DA Access Report

21125

22-24 Rodley Avenue, Penrith, NSW

ACCESS REPORT

PRE-ADAPTABLE UNIT 01 AND LIVABLE

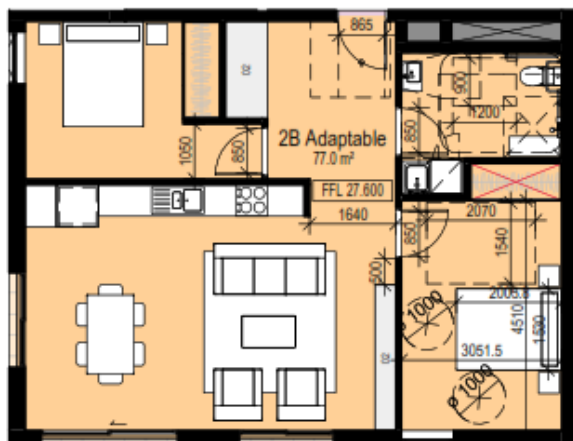
The units designated as adaptable are unit numbers 01 and 02.

At DA stage there is insufficient information to certify compliance with the Standard, however, in accordance with the table below, the nominated units can comply with the spatial requirements of AS4299 for Adaptable Housing.

By incorporating the essential requirements listed Checklist below in the Specifications, the nominated Adaptable units can achieve full compliance with Adaptable House Class C
